Ridgefield

Danbury Road (Route 35) & Farmingville Road (Route 61)

Multi-Use Trail – Road Safety Audit

June 14, 2016

Figure 19. Short Term Recommendations

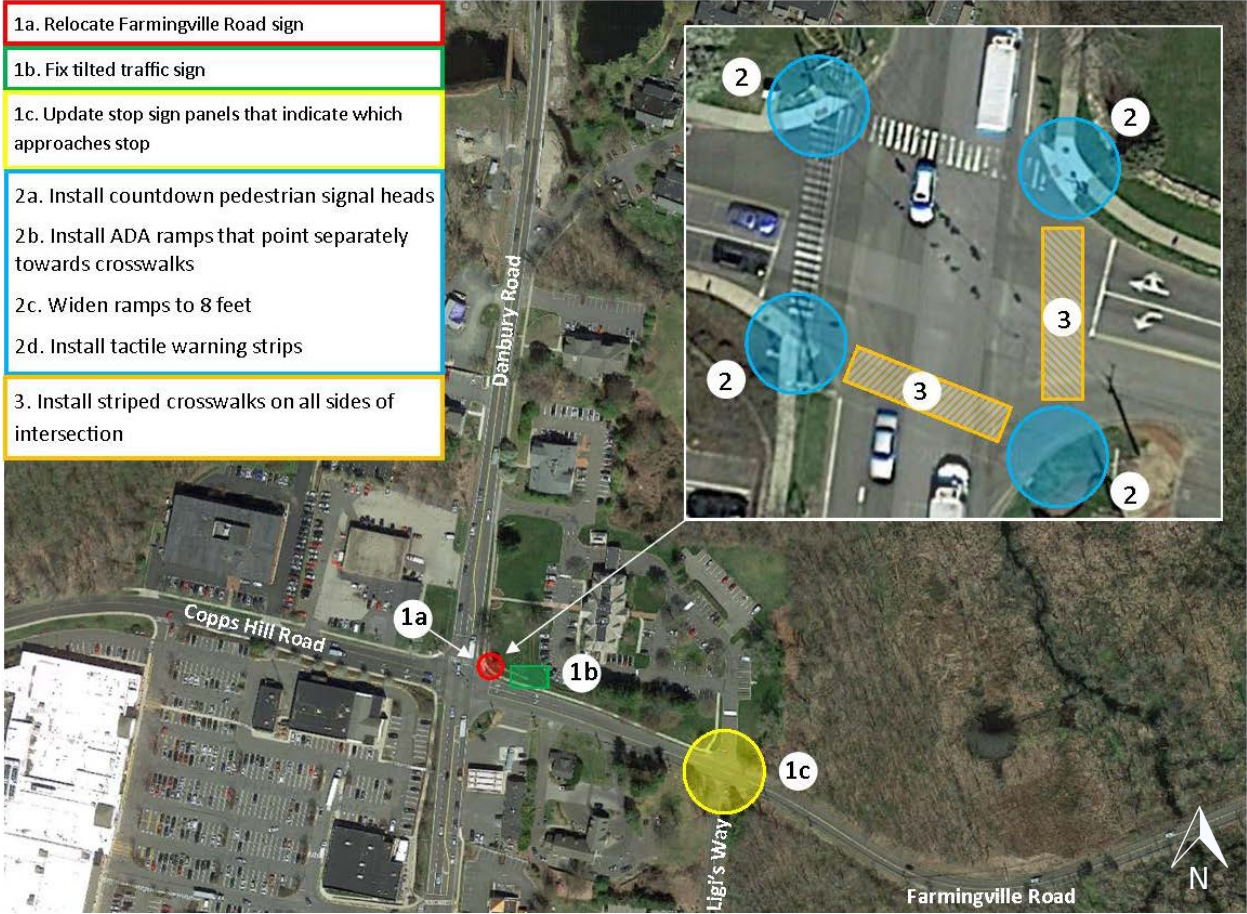
1. Signage:
 - a. Relocate Farmingville Road sign so that it does not block the pedestrian head (Figure 14).
 - b. Fix tilted traffic sign (Figure 15).
 - c. Update stop sign panels at intersection of Farmingville Road and Ligi's Way indicating which approaches stop so that they are correct and consistent (Figure 16).

2. Coordinate with CTDOT regarding the signal upgrade at Danbury Road and Farmingville Road and request the following:
 - a. Install countdown pedestrian signal heads (Figure 17) and ADA buttons and specify preferred pedestrian signal locations.

- b. Modify ADA ramps so that separate ramps point towards crosswalks instead of only one 45 degree ramp pointing into the intersection (Figure 18).
 - c. Widen ramps to eight feet to match trail way.

- d. Install tactile warning strips the entire length of the ramp.
3. Add striped crosswalks on all sides of the intersection (Figure 19).

Figure 22. Medium Term Recommendations

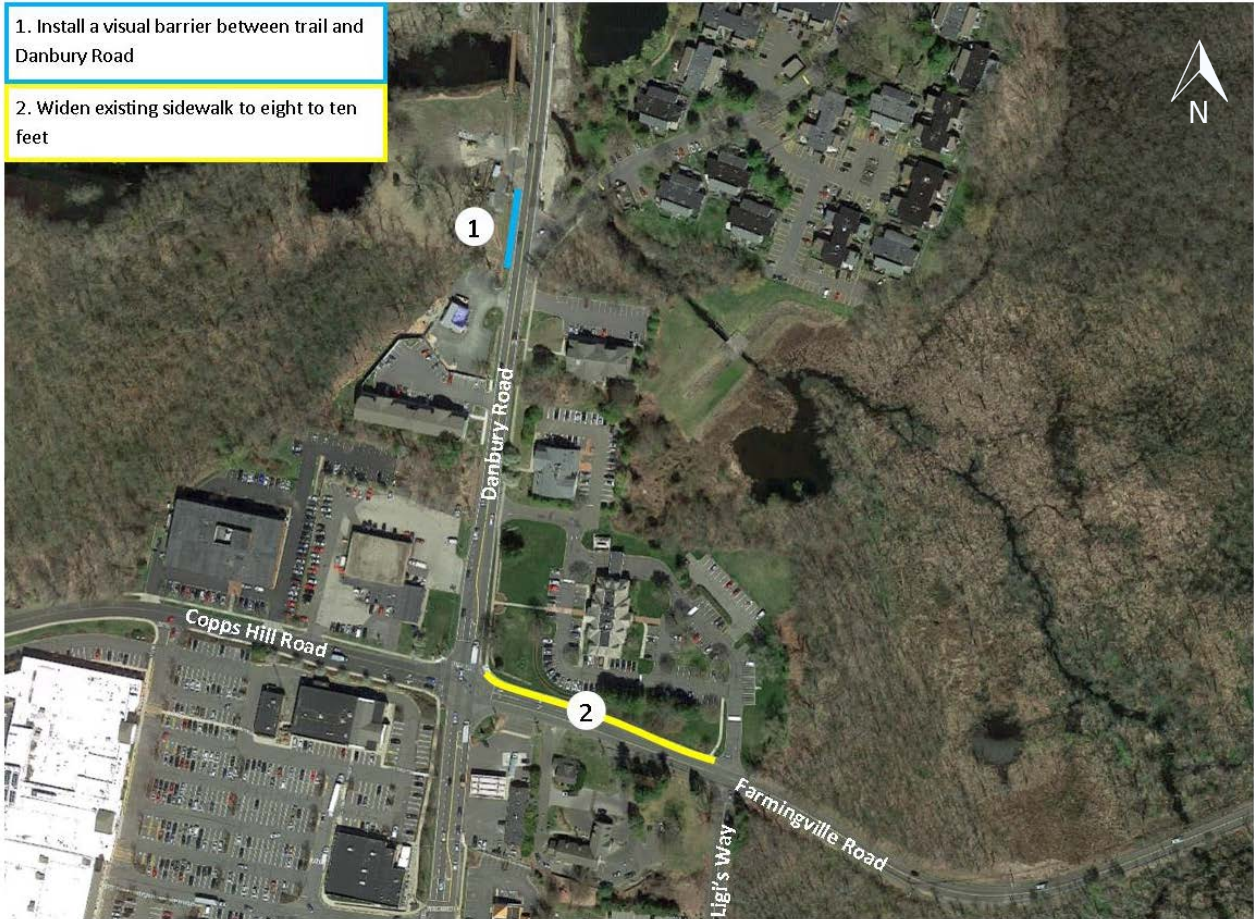
1. Install a visual barrier between the trail and Danbury Road in the vicinity of Fox Hill Road (Figure 21).
2. Widen sidewalk on north side of Farmingville Road (Figure 22) where trail is planned (8 – 10 feet).

- 1. Install a visual barrier between trail and Danbury Road
- 2. Widen existing sidewalk to eight to ten feet
